## **Response to Comments**

### **Swift Creek Action Plan, Consent Decree, and Public Participation Plan**

#### **Swift Creek Project Everson, WA**

December 2019

Please refer to attached "Consent Decree EXHIBIT A Site Diagram"

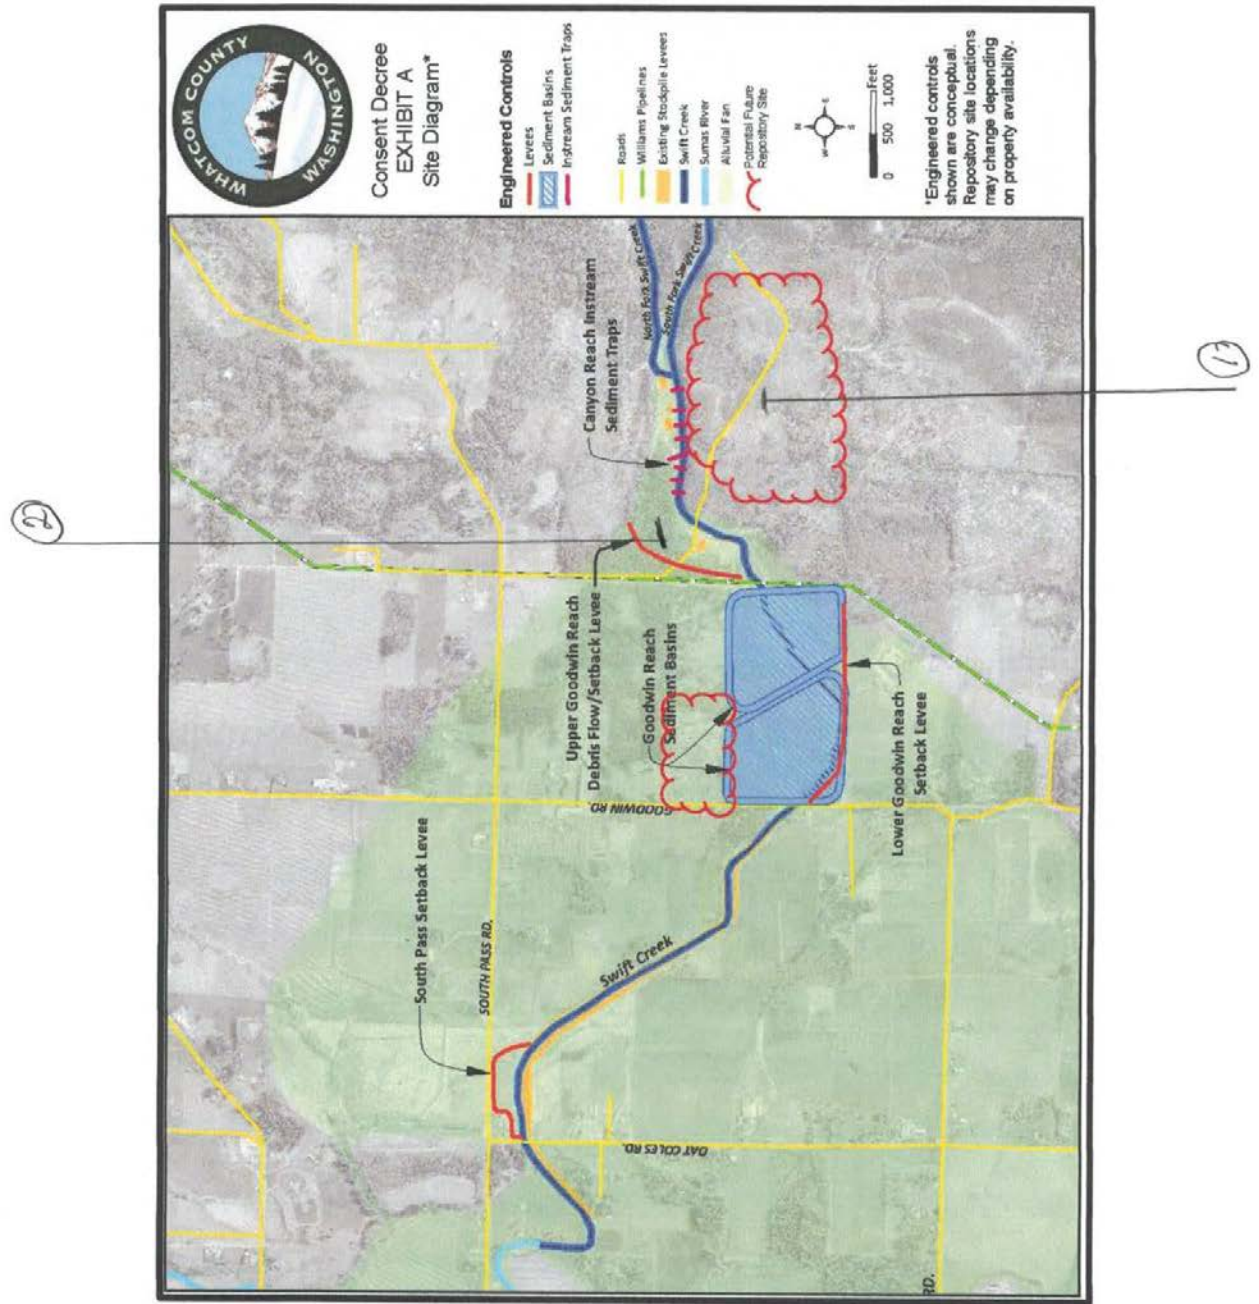
1. In mid September 2019, I, like many locals, set out to enjoy Sumas Mtn. by going for a walk. In doing so, I observed that the area described as a "Potential Future Repository Site" which is south of the "Canyon Reach Instream Sediment Traps" had been clear-cut.

2. Subsequently, and prior to the public meeting, I again went for a walk and observed another large clear-cut taking place, effectively from mid way of the sediment traps to the "Williams Pipelines". This clear cut approximates 1700 feet wide. This clear cut joins up with a clear area that begins at the point where the North and South forks of the Swift Creek join. This clear area approximates 900 feet wide and has piles of unprotected Naturally Occurring Asbestos (NOA). So effectively, there is now a clear area 2600 feet wide from the base of Sumas Mtn. to the William Pipelines.

1. Why were these clear-cuts taking place prior to the public hearing and the comments accepted time frame? These activities seem to negate any merits attributable to the meeting and comments. Apparently, the project moves ahead without consideration of the public.

2. It appears that the areas of the clear-cuts "contain critical areas, protective buffers and/or mitigation as defined by Chapter 16.16 and/or Chapter 23, Whatcom County Code" (PL4-86-002-C Rev: July 2014). The forest buffer has been eliminated. What happened here? How and why did these clear-cuts occur?

3. The rainy season is now beginning. As described in Wikipedia, "Prior to the March 2014 mudslide, the Oso area had heavy rainfall during the previous 45 days, up to 200 percent of normal". Given the loss of the forest buffer, it appears that property owners and their families have had a significant increase in the risk of a catastrophic event should the toe of the Swift Creek landslide give way. What is being done or will be done shortly to mitigate the loss of the forest buffer in this critical area?

4. The northeast winds will be coming. Given the loss of the forest buffer, what will be done to limit the NOA unprotected piles becoming airborne, and as a result, subject locals to unclean air and potentially resultant health issues?

The forest practices activity was performed by the property owner on their private property. Whatcom County does not currently own the property. Forest practices needed for future development of the sediment basins and repositories will conform to the requirements in the Consent Decree and the Swift Creek Sediment Management Action Plan including vegetative buffers, capping of sediment repositories and specific air monitoring.

Swift Creek — Roads per Text Explanation

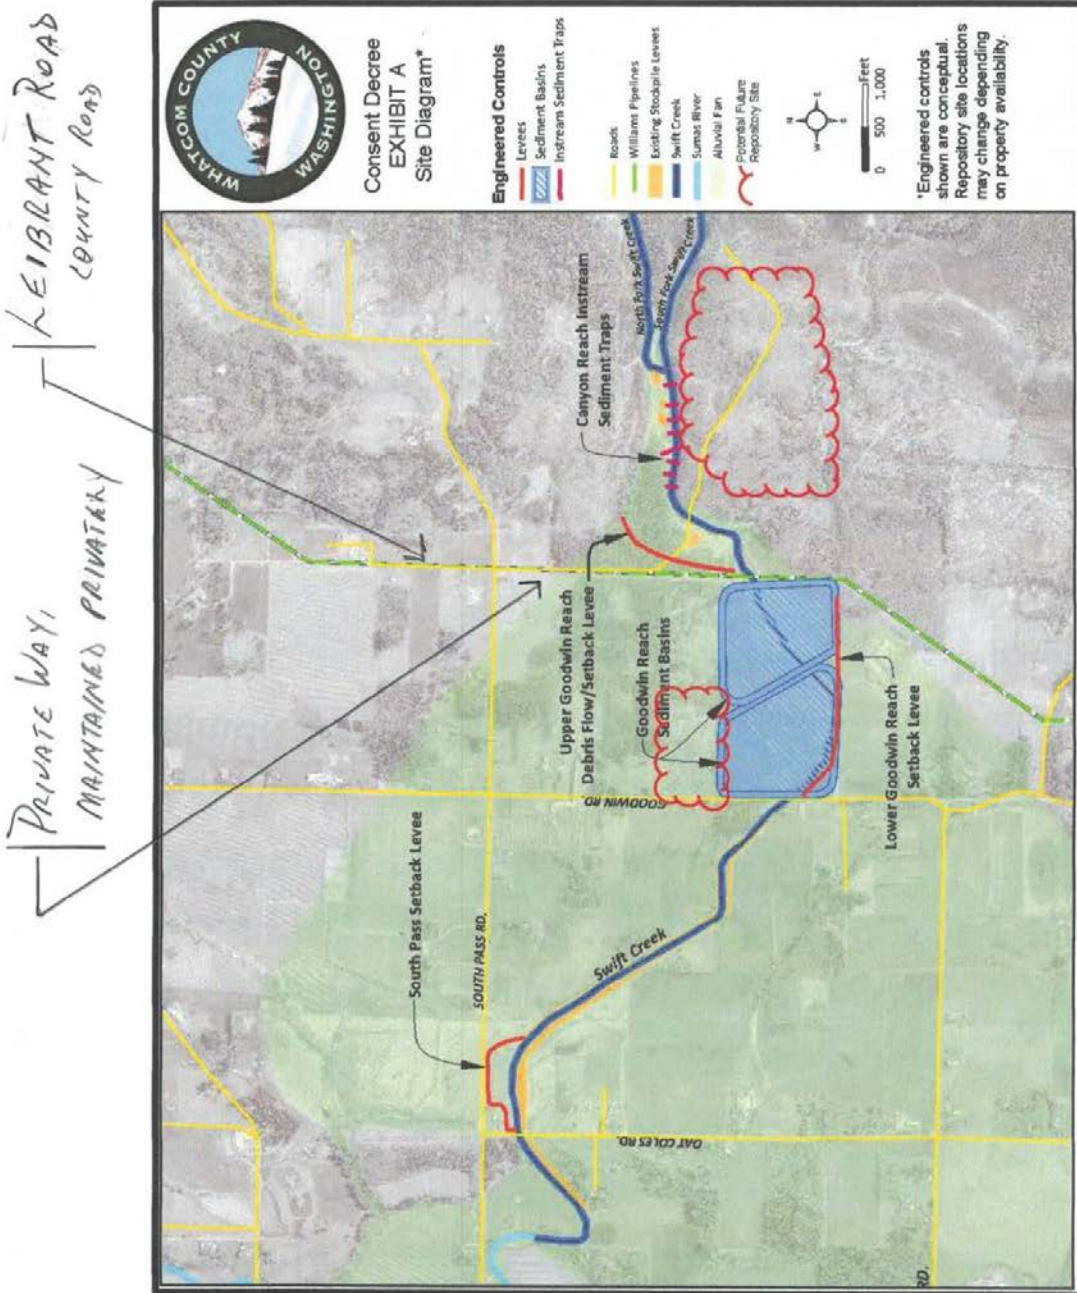
Please refer to the attached **Consent Decree EXHIBIT A Site Diagram, and to the attached text explanation entitled Swift Creek Action Plan engineered controls diagram.**

1. The text explanation relative to roads states: "...and LeibrantRoad (listed from west to east)". It appears that this statement is lacking. On the Site Diagram a yellow line is identified as a road that travels north of South Pass Rd, and south of South Pass Rd, and then turns to proceed west to east towards the Canyon Reach Instream Sediment Traps.

2. That **section north of South Pass Rd. is indeed Leibrant Rd and is a county road maintained by the county.**
3. That **section that proceeds south of South pass Rd is a private way maintained privately.** Utilization of this section would be inappropriate, detrimental to the private rural character of the area, detrimental to horses grazing, etc. in adjacent fields, and detrimental to members of the local community who utilize it as a safe way to exercise (walk, etc.).

4. **To accomplish the objective of reaching the Sediment Traps with the least negative impact would be to utilize the way that Great Western currently uses to access that area.** This Great Western way starts on the east side of the Goodwin Rd just north of Swift Creek.

Swift Creek - EXHIBIT A

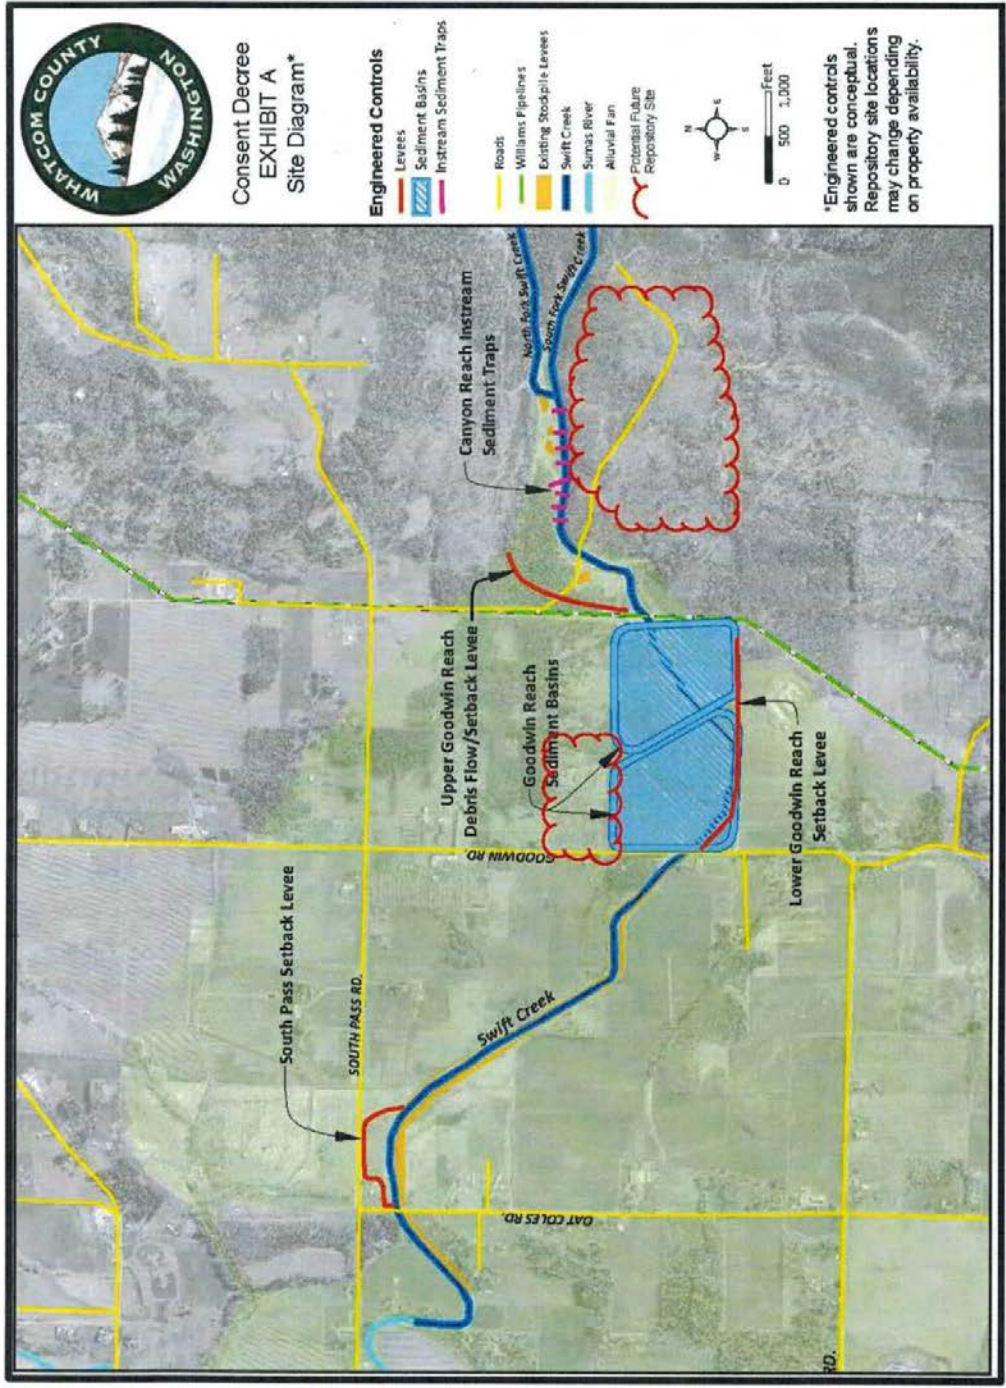
Please refer to the attached Consent Decree EXHIBIT A Site Diagram, and to the attached text explanation entitled Swift Creek Action Plan engineered controls diagram.

Please refer to attached "Consent Decree EXHIBIT A Site Diagram"

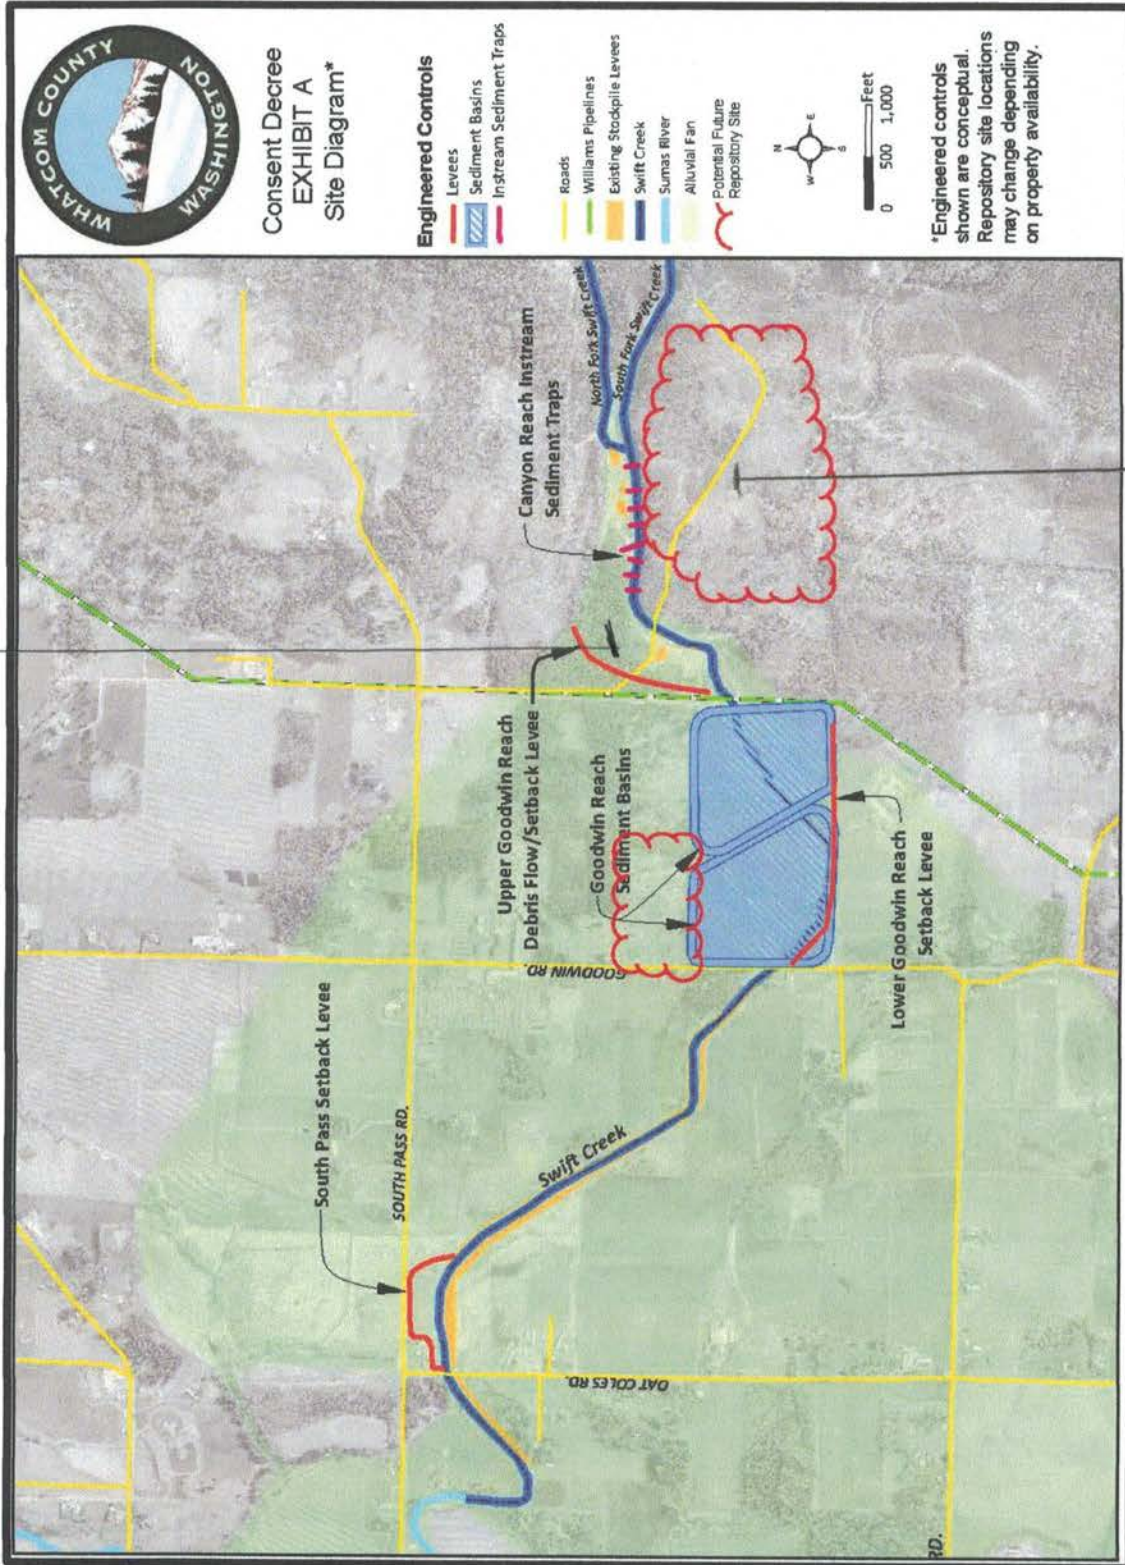
1. In mid September 2019, I, like many locals, set out to enjoy Sumas Mtn. by going for a walk. In doing so, I observed that the area described as a "Potential Future Repository Site" which is south of the "Canyon Reach Instream Sediment Traps" had been clear-cut.
2. Subsequently, and prior to the public meeting, I again went for a walk and observed another large clear-cut taking place, effectively from mid way of the sediment traps to the "Williams Pipelines". This clear cut approximates 1700 feet wide. This clear cut joins up with a clear area that begins at the point where the North and South forks of the Swift Creek join. This clear area approximates 900 feet wide and has piles of unprotected Naturally Occurring Asbestos (NOA). So effectively, there is now a clear area 2600 feet wide from the base of Sumas Mtn. to the William Pipelines.

1. Why were these clear-cuts taking place prior to the public hearing and the comments accepted time frame? These activities seem to negate any merits attributable to the meeting and comments. Apparently, the project moves ahead without consideration of the public.

Swift Creek – Roads per Text Explanation

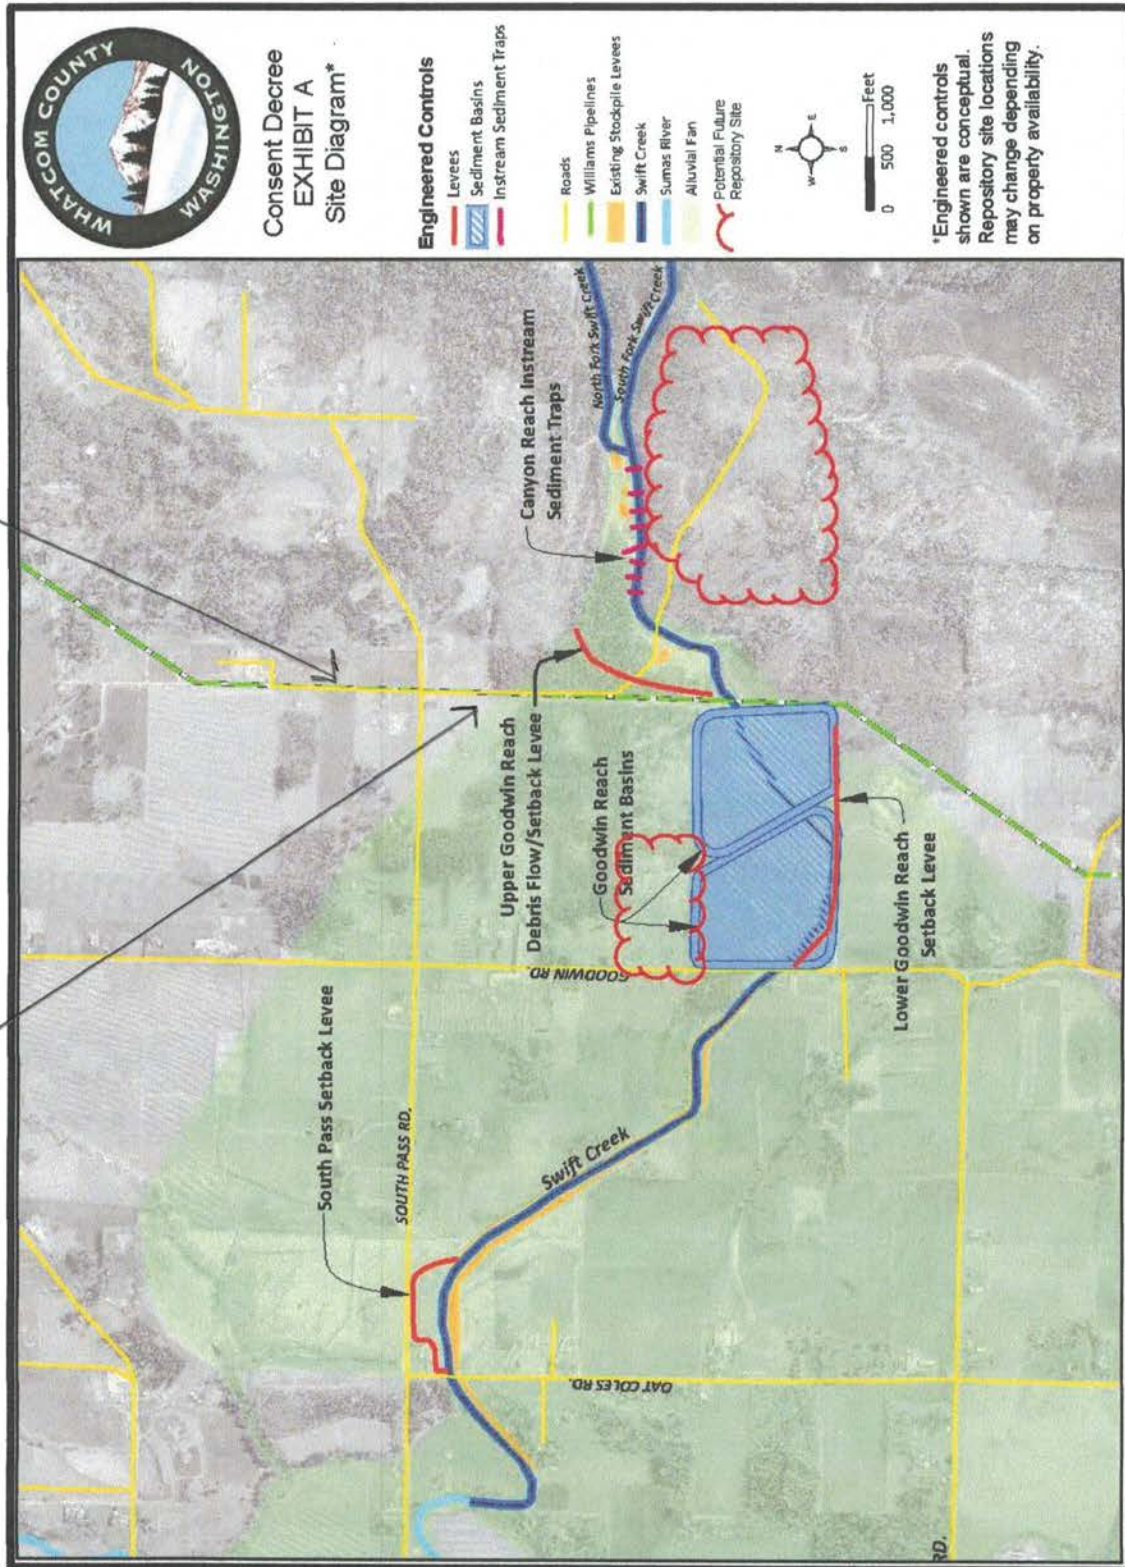
Please refer to the attached **Consent Decree EXHIBIT A Site Diagram**, and to the attached text explanation entitled **Swift Creek Action Plan engineered controls diagram**.

1. The text explanation relative to roads states: "...and Leibrant Road (listed from west to east)". It appears that this statement is lacking. On the Site Diagram a yellow line is identified as a road that travels north of South Pass Rd, and south of South Pass Rd, and then turns to proceed west to east towards the Canyon Reach Instream Sediment Traps.

4. **To accomplish the objective of reaching the Sediment Traps with the least negative impact would be to utilize the way that Great Western currently uses** to access that area. This Great Western way starts on the east side of the Goodwin Rd just north of Swift Creek.

KEIBRANT ROAD  
COUNTY ROAD

PRIVATE WAY,  
MAINTAINED PRIVATELY
